**ADDENDUM NO. 3**

IRONDALE FIRE STATION No. 3

THIS ADDENDUM FORMS A PART OF THE CONTRACT DOCUMENTS. THE FOLLOWING CONDITIONS TAKE PRECEDENCE OVER ANY CONFLICTING CONDITIONS IN THE DRAWINGS AND SPECIFICATIONS. THE DRAWINGS AND SPECIFICATIONS ARE HEREBY AMENDED IN THE FOLLOWING PARTICULARS.

Level 1 Plan - Power  
 1/8" = 1'-0"

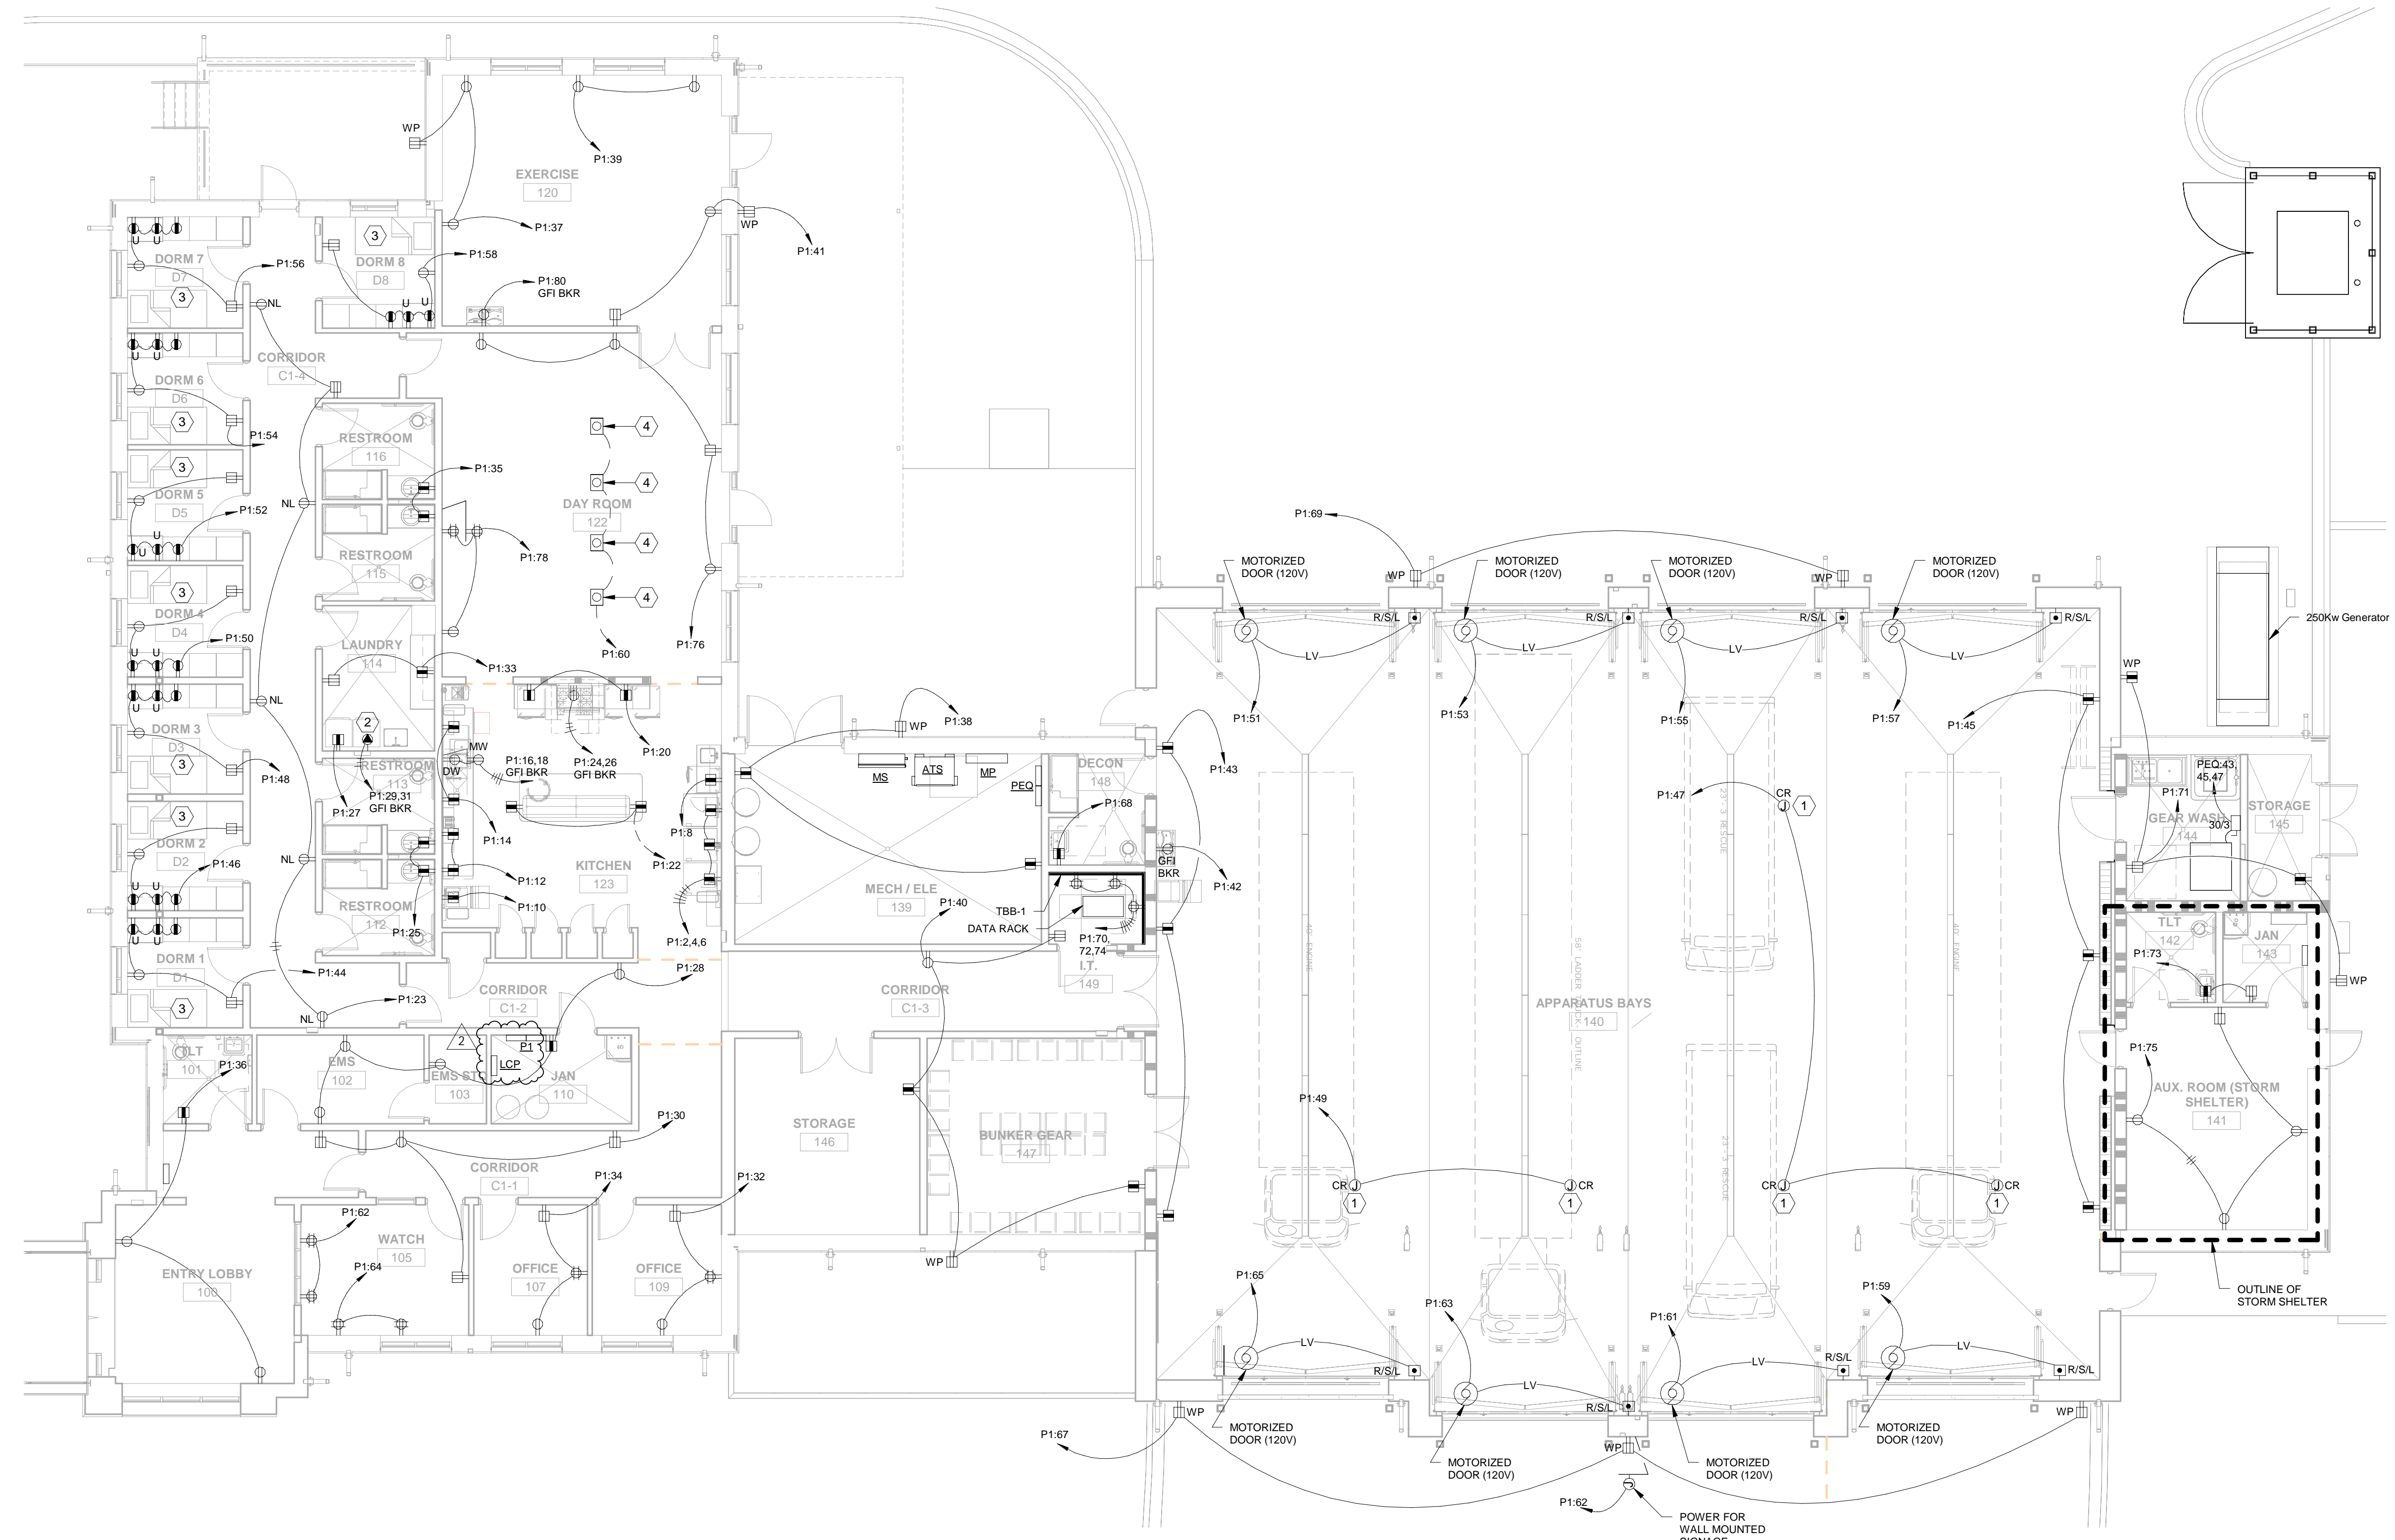
- b. Added location for LCP Panel.
28. E202 Level 1 Plan Power:
  - a. Moved Panel 'P1' into Janitor Closet #110.
  - b. Added location for LCP Panel.
29. E203 Level 1 Plan Auxiliary:
